**Comments from Transport Department**  
**(Contact Person: Mr. POON Chi Hang, Gary; Tel: 2399 2549)**

### **Comments from Urban Design & Landscape Section of Planning Department (Contact Person: Mr. CHUI Wai Lun, Martin, Tel: 3565 3947)**

**Comments from Sha Tin, Tai Po and North District Planning Office of Planning Department**

# 附件一(地圖及相片)

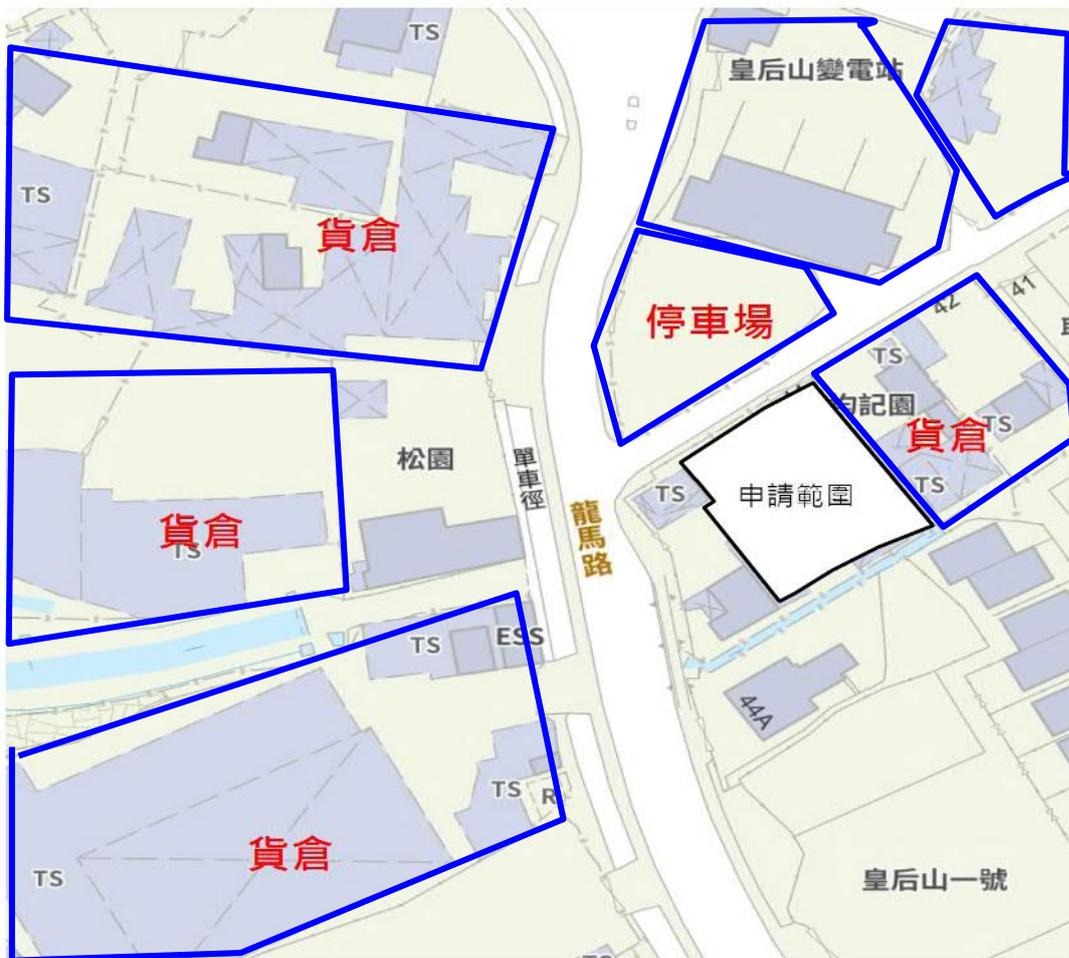
1. It is found that an existing tree would obstruct the swept path. Please clarify whether the tree at the access point will be fell. If not, please update the swept path analysis to demonstrate the satisfactory maneuvering of vehicles entering to and exiting from the application site (the Site) with the presence of the tree.

2. According to the application form, tree felling is not involved. However, it is noted from drawing F1 of the planning statement that the trees in the site will be felled due to concrete filling, including a possible distinctive landscape resource (e.g. Tree of Particular Interest or mature tree) is identified within the Site. The applicant has not provided any information to address the possible adverse landscape impact on the tree concerned.

有關的樹在申請規劃前已經被移除，（2024/11/29接到發展局的通知需要處理）。

有關的樹在申請規劃前已經被移除，（2024/11/29接到發展局的通知需要處理）。

上述樹木

樹根霸佔大部分的行人路，對行人構成生命威脅

石屎導管

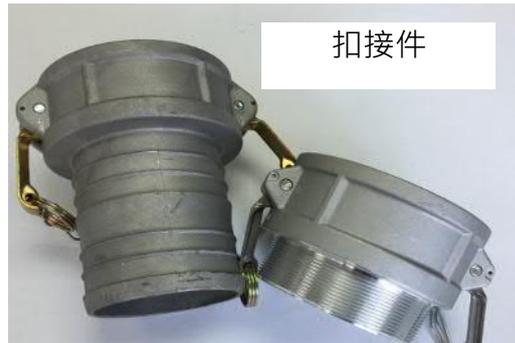
- (a) It is noted from the application form that the proposed warehouse is intended for storage of metal parts and tools in support of a firm providing concrete pump services. Please clarify what type(s) of good(s)/product(s) will be stored, and whether the concrete pump services will be conducted on-site.

主要用作存放 (全新) 物料包括輸送石屎的內喉管、喉管接頭扣接件及工具等，請參閱有關附件相片
